RIL 2021-05

Evaluation of ASCE 4-16 and ASCE 43-18 (Draft) for Use in the Risk-Informed, Performance-Based Seismic Design of Nuclear Power Plant Structures, Systems, and Components

**Research Information Letter
Office of Nuclear Regulatory Research**

FIGURE 3-1. Distribution of Fluid Mass for Horizontal Seismic Response Analysis of Basins with Flexible Walls and/or Local Stress Problems

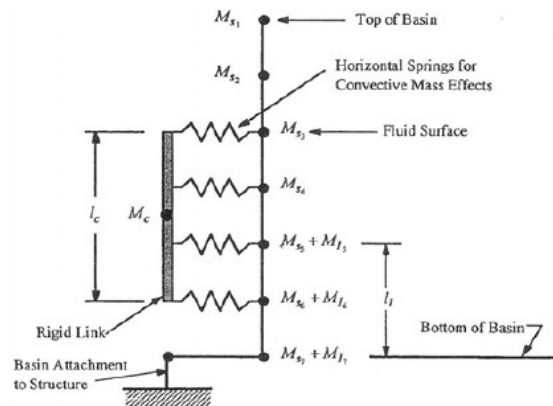
ASCE 4-16 does not provide the technical basis for Figure 3-1. Commentary Section C3.6.3 provides no additional information or references for Figure 3-1; it simply states, "If the walls are not relatively rigid and/or the local stress effects are important, then the impulsive mass and convective spring constants should be distributed as specified in this standard." Implementations of Figure 3-1 for analysis of hydrodynamic mass effects should be peer-reviewed for technical adequacy.

ASCE 4-16, Section 3.6.3(c), describes the treatment of impulsive mass and sloshing mass for situations where the basin wall is not rigid or when local stresses are of interest, as depicted in Figure 3-1; however, it provides no references for the technical basis. The Commentary provides no additional information or references for Figure 3-1; it simply states, “If the walls are not relatively rigid and/or the local stress effects are important, then the impulsive mass and convective spring constants should be distributed as specified in this standard.” Implementations of Figure 3-1 should be peer-reviewed for technical adequacy.

FIGURE 3-2. Decoupling Criteria for Secondary Systems with Single-Point Attachment to the Primary System

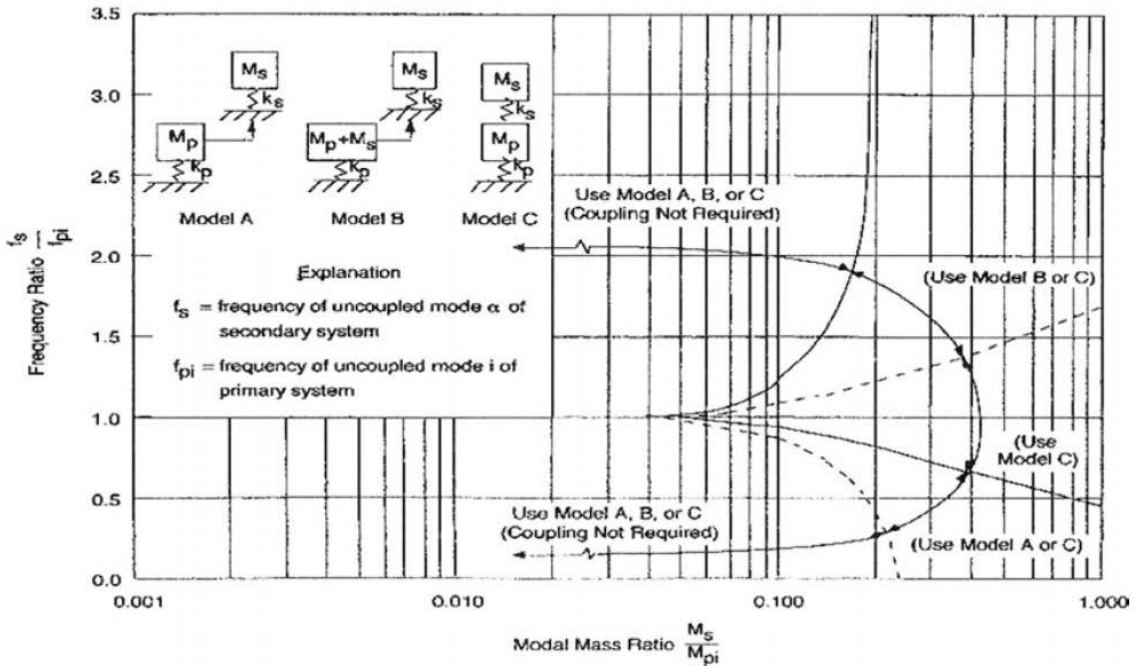
In many cases, supported components may be amenable to modeling with a single degree of freedom (SDOF) but are attached to supporting MDOF structure or system models. Therefore, the decoupling criteria in ASCE 4-16, Section 3.7.2(a), Figure 3-2, applicable to an SDOF supporting element and SDOF supported element, must be implemented with caution. Commentary Section C3.7.2 states, “Therefore, the application of the criteria in Fig. 3-2 to practical situations such as multi-degrees-of-freedom secondary systems multiply connected to several multi-degrees-of-freedom primary systems requires judgment, caution, and additional considerations.” Consequently, implementations of the criteria in Figure 3-2 for MDOF supporting elements and either MDOF or SDOF supported elements should be peer-reviewed for technical adequacy.

The above information shows that implementing the provisions of ASCE 4-16, Section 3.7, may involve a substantial calculational effort to satisfy decoupling criteria for multi-degree-of-freedom (MDOF) mathematical models typical of those developed for seismic/structural analysis of nuclear power plant SSCs. In many cases, supported components may be amenable to modeling with a SDOF but are attached to supporting MDOF structure or system models. Therefore, the decoupling criteria in ASCE 4-16, Section 3.7.2(a), Figure 3-2, applicable to an SDOF supporting element and SDOF supported element, must be implemented with caution. Commentary Section C3.7.2 states, "Therefore, the application of the criteria in Fig. 3-2 to practical situations such as multi-degrees-of-freedom secondary systems multiply connected to several multi-degrees-of-freedom primary systems requires judgment, caution, and additional considerations." Consequently, implementations of the criteria in Figure 3-2 for MDOF supporting elements and either MDOF or SDOF supported elements should be peer-reviewed for technical adequacy.

Commentary Section C3.7.2 also states, "Fig. 3-2 allows up to 10% error in the coupled modal frequency. The structural response error may be larger but is always on the conservative side." This is apparently more generous than the current SRP guidance. Applying SRP criteria to Figure 3-2, a vertical line would be drawn at a mass ratio of 0.10; above 0.10, coupling is required regardless of the frequency ratio.

BNL recommends the use of a coupled model if the uncoupled response is unconservative by more than 5 percent relative to coupled response, to ensure that decoupling will not contribute significantly to underprediction of the seismic response.
